**SUSQUEHANNA STEAM ELECTRIC STATION
PROPOSED AMENDMENT NO. 254 TO LICENSE NFP-14
AND PROPOSED AMENDMENT NO. 219 TO LICENSE NFP-22:
REVISED RESPONSE TO GL 94-02:
LONG-TERM STABILITY SOLUTION
PLA-5620**

ENCLOSURE to PLA-5620

REVISED RESPONSE TO GL 94-02: LONG-TERM STABILITY SOLUTION

**Proposed Technical Specification Changes
(Markups)**

Figure 3.4.1-1

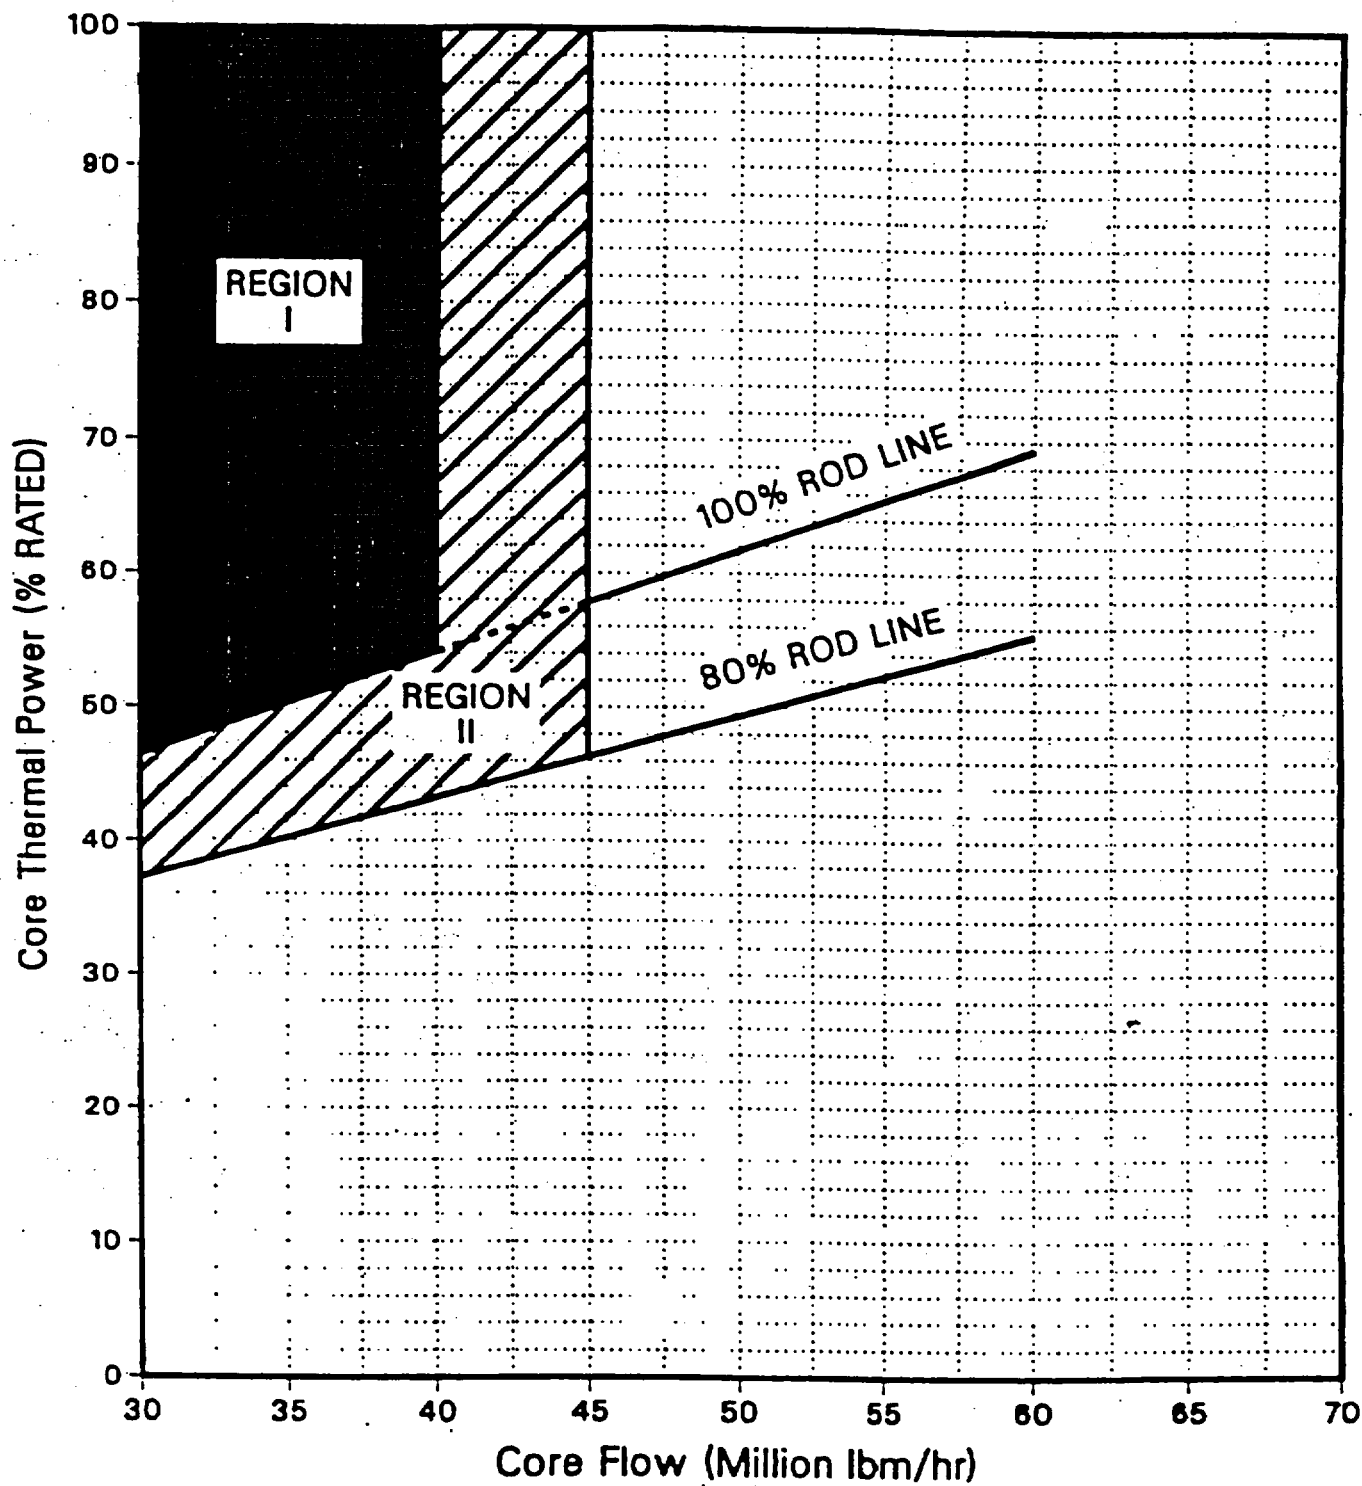
LCO 3.4.1 Two recirculation loops with matched flows shall be in operation with a THERMAL POWER/core flow condition outside of Regions I and II of Figure 3.4.1-1.

One recirculation loop may be in operation provided the following limits are applied when the associated LCO is applicable with a THERMAL POWER/core flow condition outside of Regions I and II of Figure 3.4.1-1.

CONDITION	REQUIRED ACTION	COMPLETION TIME
<p>A. Total core flow as a function of THERMAL POWER within Region I of Figure 3.4.1-1.</p> <p><u>OR</u></p> <p>No recirculation loops operating while in MODE 1</p>	<p>A.1 Place reactor mode switch in the shutdown position.</p>	<p>Immediately</p>
<p>B. -----NOTE----- Only applicable when in Region II of Figure 3.4.1-1</p> <p>Two or more APRM readings oscillating with one or more oscillating $\geq 10\%$ of RTP peak-to-peak.</p> <p><u>OR</u></p> <p>Two or more LPRM upscale alarms activating and deactivating with a period ≥ 1 second and ≤ 5 seconds.</p> <p><u>OR</u></p> <p>Sustained LPRM oscillations > 10 w/cm² peak-to-peak with a period ≥ 1 second and ≤ 5 seconds.</p> <p><u>OR</u></p>	<p>B.1 Place the reactor mode switch in the shutdown position.</p>	<p>Immediately</p> <p>(continued)</p>

CONDITION	REQUIRED ACTION	COMPLETION TIME
B. (continued) Less than 50% of required LPRM upscale alarms OPERABLE (4)		
C. Total core flow as a function of THERMAL POWER within Region II of Figure 3.4.1-1.	C.1 Initiate action to restore total core flow as a function of THERMAL POWER outside of Region II.	Immediately
D. Recirculation loop flow mismatch not within limits.	D.1 Declare the recirculation loop with lower flow to be "not in operation."	2 hours
E. No recirculation loops in operation while in MODE 2 (3) <u>OR</u> Single Recirculation Loop required limits and setpoints not established within required time.	E.1 Be in MODE 3.	12 hours

Figure 3.4.1-1

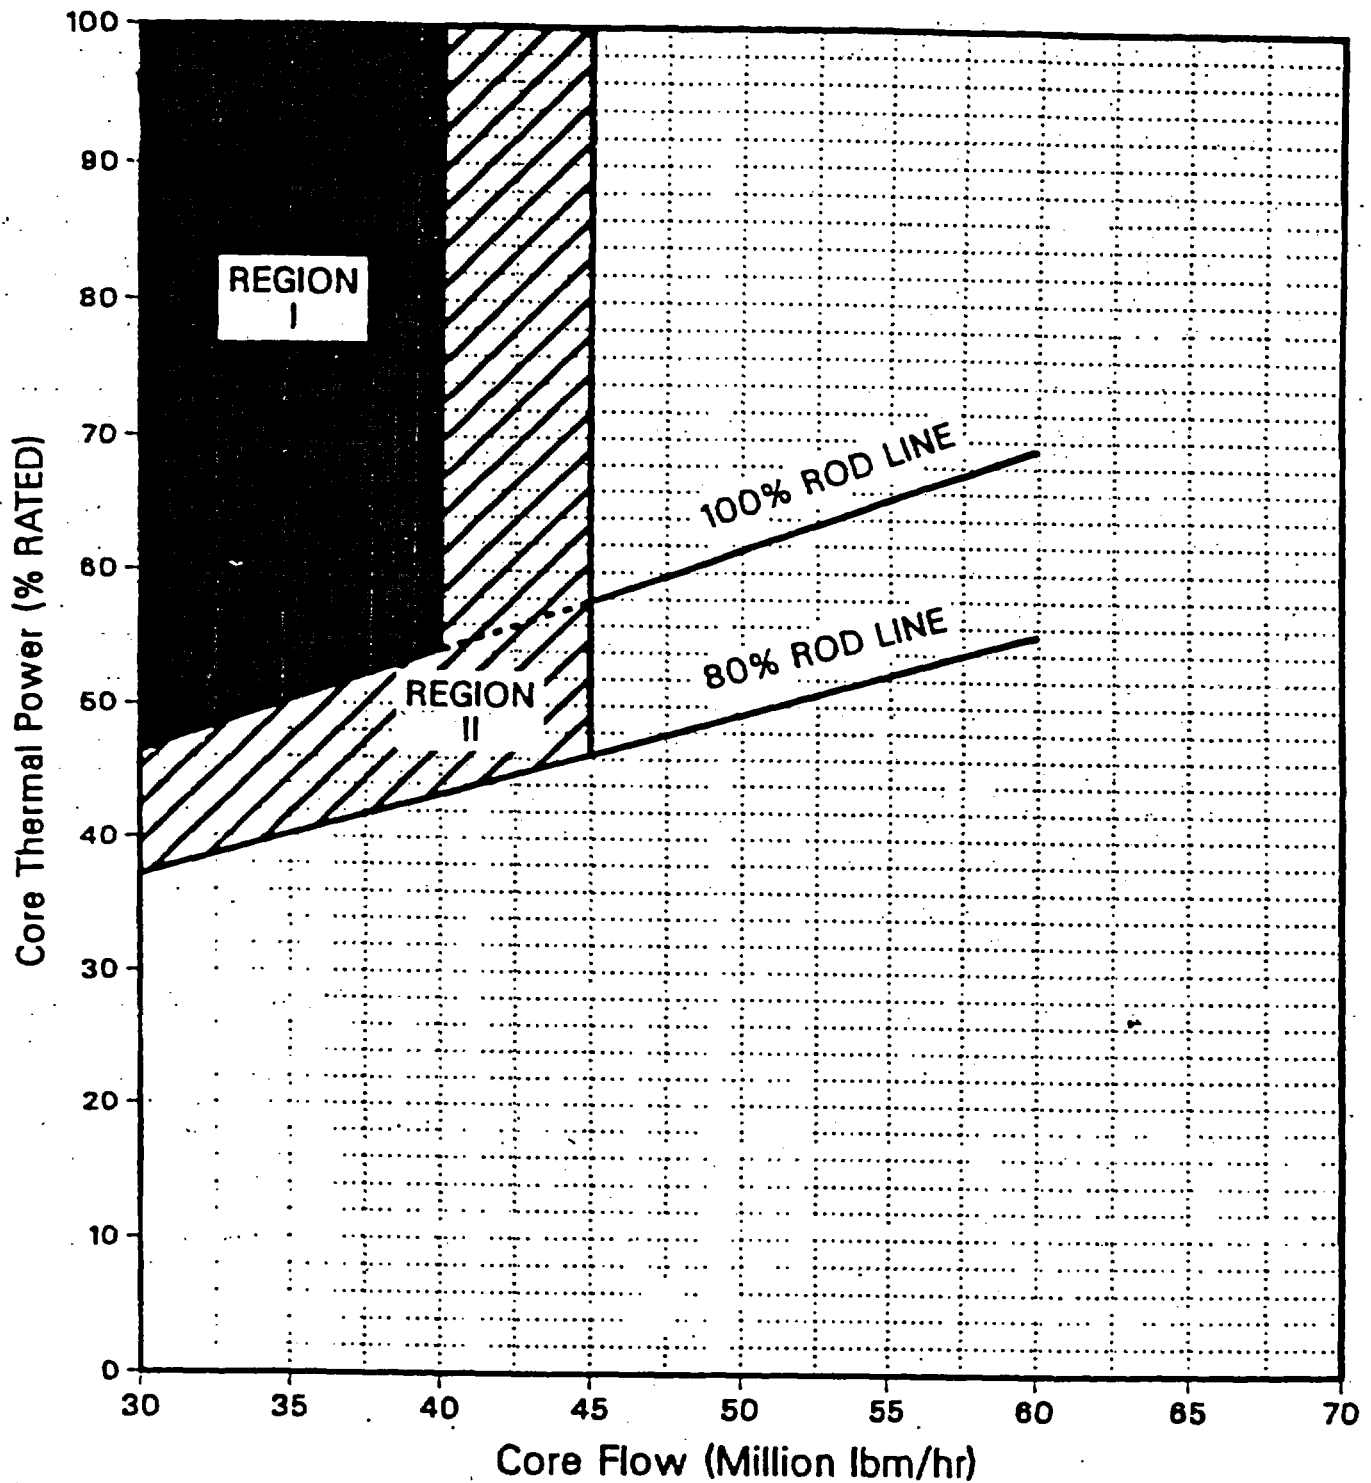
LCO 3.4.1 Two recirculation loops with matched flows shall be in operation with a THERMAL POWER/core flow condition outside of Regions I and II of Figure 3.4.1-1.

One recirculation loop may be in operation with a THERMAL POWER/core flow condition outside of Regions I and II of Figure 3.4.1-1 provided the following limits are applied when the associated LCO is applicable:

CONDITION	REQUIRED ACTION	COMPLETION TIME
<p>A. Total core flow as a function of THERMAL POWER within Region I of Figure 3.4.1-1.</p> <p><u>OR</u></p> <p>No recirculation loops operating while in MODE 1</p>	<p>A.1 Place reactor mode switch in the shutdown position.</p>	<p>Immediately</p>
<p>B. -----NOTE----- Only applicable when in Region II of Figure 3.4.1-1</p> <p>Two or more APRM readings oscillating with one or more oscillating $\geq 10\%$ of RTP peak-to-peak.</p> <p><u>OR</u></p> <p>Two or more LPRM upscale alarms activating and deactivating with a period ≥ 1 second and ≤ 5 seconds.</p> <p><u>OR</u></p> <p>Sustained LPRM oscillations > 10 w/cm² peak-to-peak with a period ≥ 1 second and ≤ 5 seconds.</p> <p><u>OR</u></p>	<p>B.1 Place the reactor mode switch in the shutdown position.</p>	<p>Immediately</p> <p>(continued)</p>

CONDITION	REQUIRED ACTION	COMPLETION TIME
B. (continued) Less than 50% of required LPRM upscale alarms OPERABLE ☹		
C. Total core flow as a function of THERMAL POWER within Region II of Figure 3.4.1-1.	C.1 Initiate action to restore total core flow as a function of THERMAL POWER outside of Region II.	Immediately
D. Recirculation loop flow mismatch not within limits.	D.1 Declare the recirculation loop with lower flow to be "not in operation."	2 hours
E. No recirculation loops in operation while in MODE 2 ☹ <u>OR</u> Single Recirculation Loop required limits and setpoints not established within required time.	E.1 Be in MODE 3.	12 hours

Figure 3.4.1-1
Thermal Power Stability Restrictions

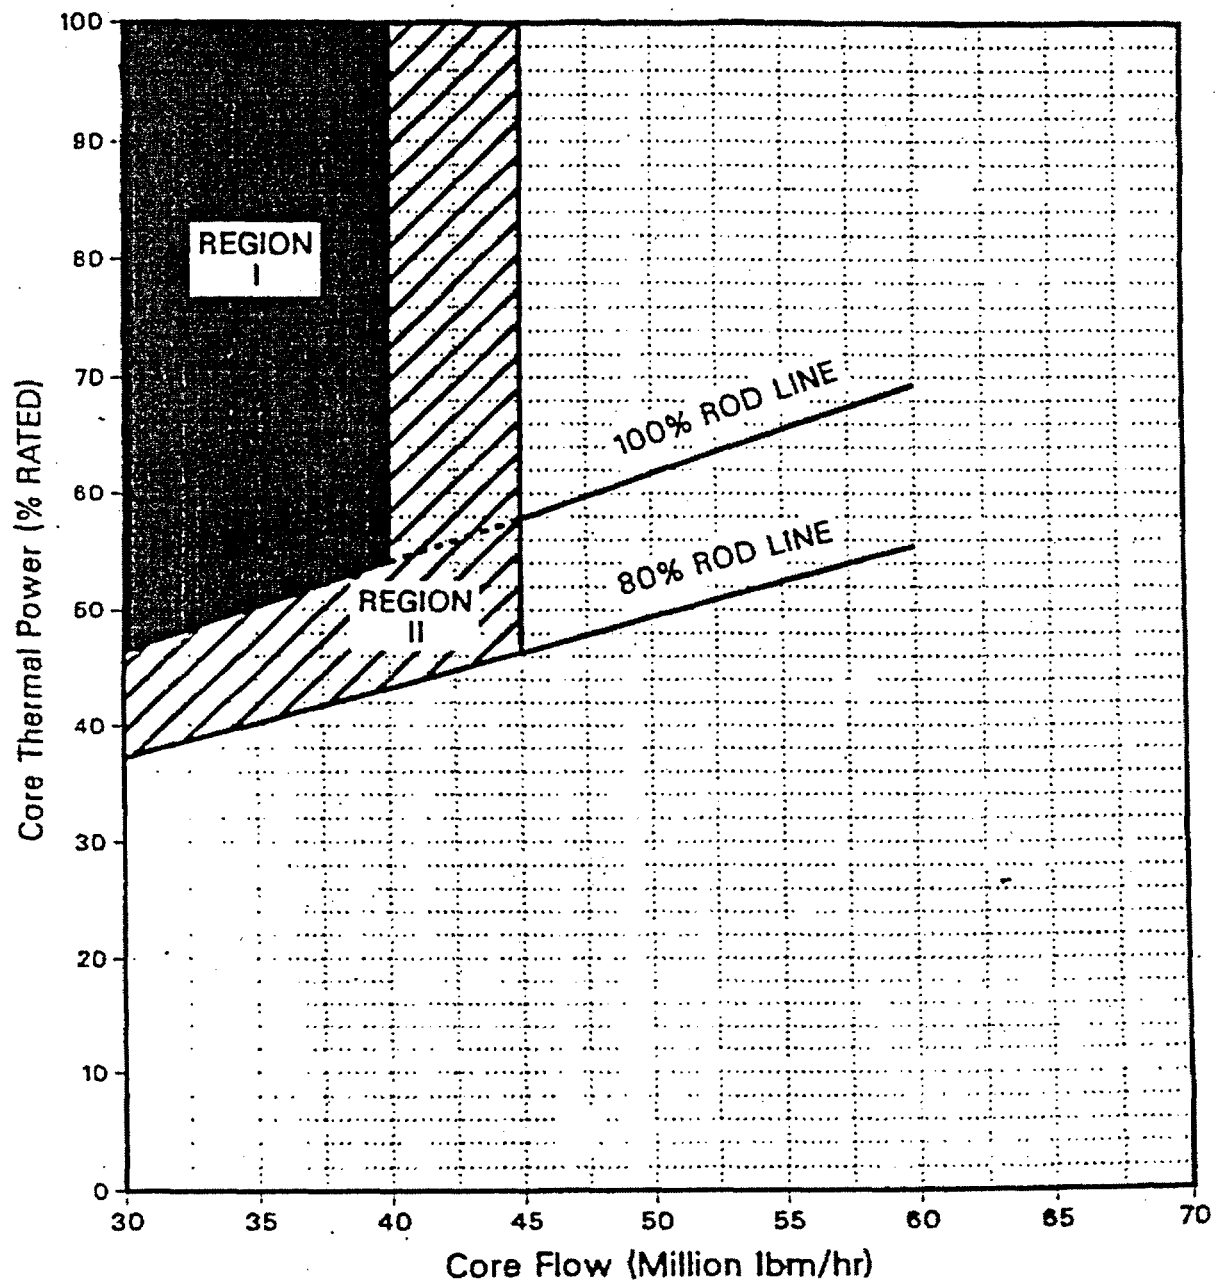
Two recirculation loops with matched flows shall be in operation with a THERMAL POWER/core flow condition outside of Regions I and II of Figure 3.4.1-1.

One recirculation loop may be in operation with a THERMAL POWER/core flow condition outside of Regions I and II of Figure 3.4.1-1 provided the following limits are applied when the associated LCO is applicable.

ACTIONS		
CONDITION	REQUIRED ACTION	COMPLETION TIME
<p>A. Total core flow as a function of THERMAL POWER within Region I of Figure 3.4.1-1.</p> <p><u>OR</u></p> <p>No recirculation loops operating while in MODE 1.</p>	<p>A.1 Place reactor mode switch in the shutdown position.</p>	<p>Immediately</p>
<p>B. -----NOTE----- Only applicable when in Region II of Figure 3.4.1-1. -----</p> <p>Two or more APRM readings oscillating with one or more oscillating $\geq 10\%$ of RTP peak-to-peak.</p> <p><u>OR</u></p> <p>Two or more LPRM upscale alarms activating and deactivating with a period ≥ 1 second and ≤ 5 seconds.</p> <p><u>OR</u></p> <p>Sustained LPRM oscillations $> 10 \text{ w/cm}^2$ peak-to-peak with a period ≥ 1 second and ≤ 5 seconds.</p> <p><u>OR</u></p> <p>Less than 50% of required LPRM upscale alarms OPERABLE.</p>	<p>B.1 Place the reactor mode switch in the shutdown position.</p>	<p>Immediately</p>

CONDITION	REQUIRED ACTION	COMPLETION TIME
C. Total core flow as a function of THERMAL POWER within Region II of Figure 3.4.1-1.	C.1 Initiate action to restore total core flow as a function of THERMAL POWER outside of Region II.	Immediately
D. Recirculation loop flow mismatch not within limits.	D.1 Declare the recirculation loop with lower flow to be "not in operation."	2 hours
E. No recirculation loops in operation while in MODE 2. <u>OR</u> Single Recirculation Loop required limits and setpoints not established within required time.	E.1 Be in MODE 3.	12 hours

Figure 3.4.1-1

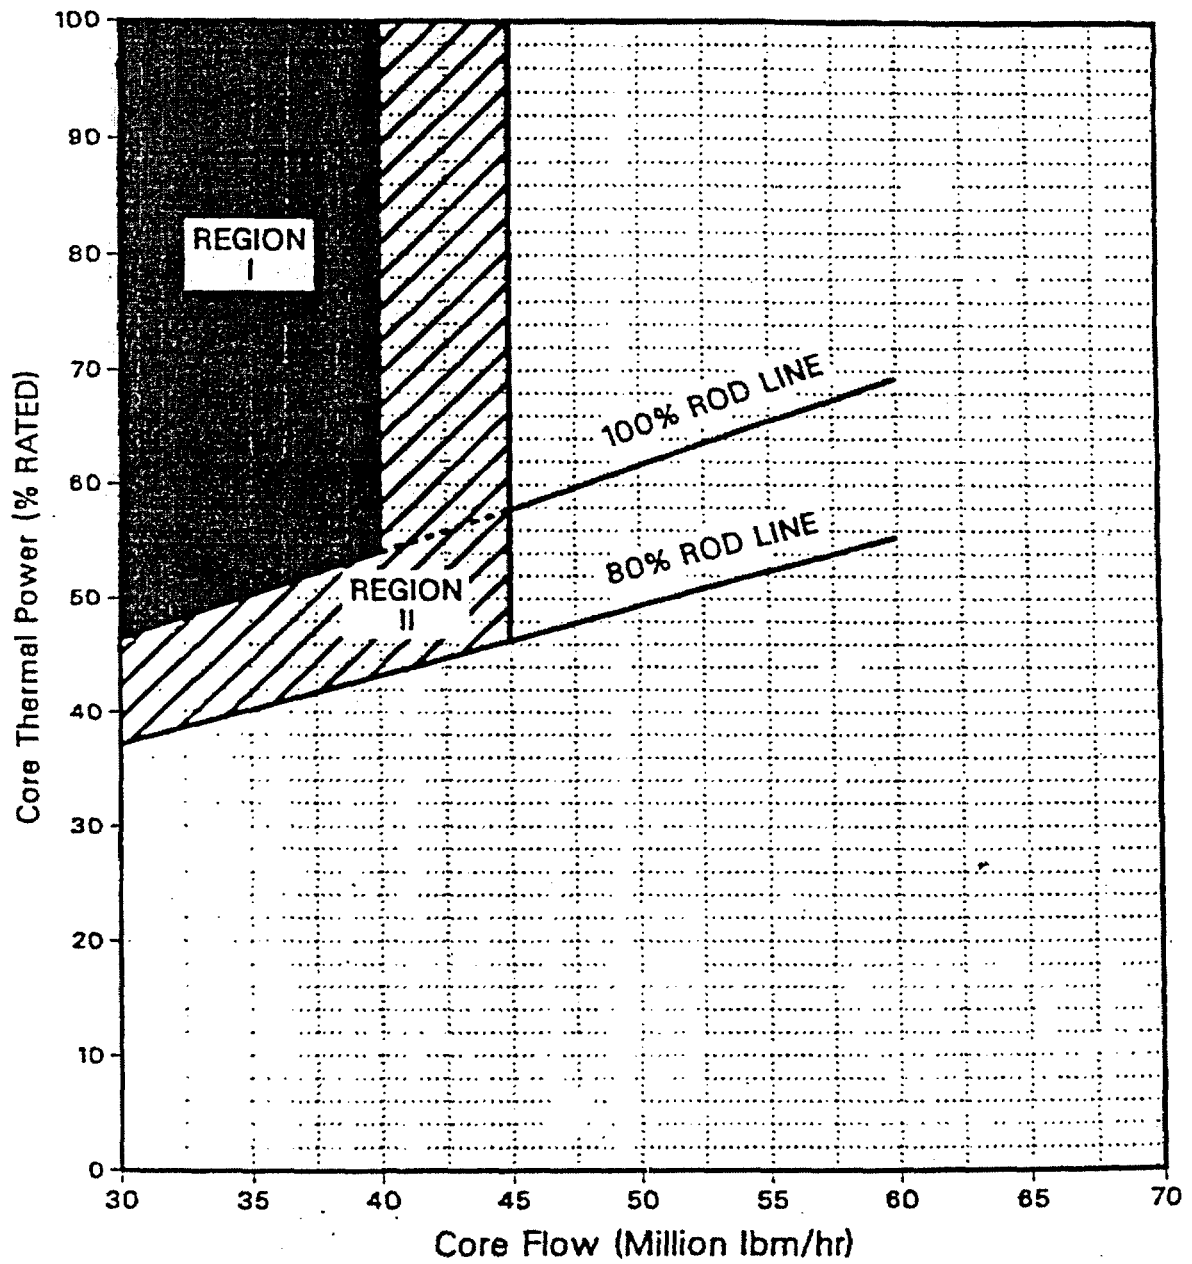
LCO 3.4.1 Two recirculation loops with matched flows shall be in operation with a THERMAL POWER/core flow condition outside of Regions I and II of Figure 3.4.1-1.

One recirculation loop may be in operation with a THERMAL POWER/core flow condition outside of Regions I and II of Figure 3.4.1-1 provided the following limits are applied when the associated LCO is applicable:

ACTIONS		
CONDITION	REQUIRED ACTION	COMPLETION TIME
<p>A. Total core flow as a function of THERMAL POWER within Region I of Figure 3.4.1-1.</p> <p><u>OR</u></p> <p>No recirculation loops operating while in MODE 1.</p>	<p>A.1 Place reactor mode switch in the shutdown position.</p>	<p>Immediately</p>
<p>B. -----NOTE----- Only applicable when in Region II of Figure 3.4.1-1.</p> <hr/> <p>Two or more APRM readings oscillating with one or more oscillating $\geq 10\%$ of RTP peak-to-peak.</p> <p><u>OR</u></p> <p>Two or more LPRM upscale alarms activating and deactivating with a period ≥ 1 second and ≤ 5 seconds.</p> <p><u>OR</u></p> <p>Sustained LPRM oscillations $> 10 \text{ w/cm}^2$ peak-to-peak with a period ≥ 1 second and ≤ 5 seconds.</p> <p><u>OR</u></p> <p>Less than 50% of required LPRM upscale alarms OPERABLE.</p>	<p>B.1 Place the reactor mode switch in the shutdown position.</p>	<p>Immediately</p>

CONDITION	REQUIRED ACTION	COMPLETION TIME
C. Total core flow as a function of THERMAL POWER within Region II of Figure 3.4.1-1.	C.1 Initiate action to restore total core flow as a function of THERMAL POWER outside of Region II.	Immediately
D. Recirculation loop flow mismatch not within limits.	D.1 Declare the recirculation loop with lower flow to be "not in operation."	2 hours
E. No recirculation loops in operation while in MODE 2. <u>OR</u> Single Recirculation Loop required limits and setpoints not established within required time.	E.1 Be in MODE 3.	12 hours
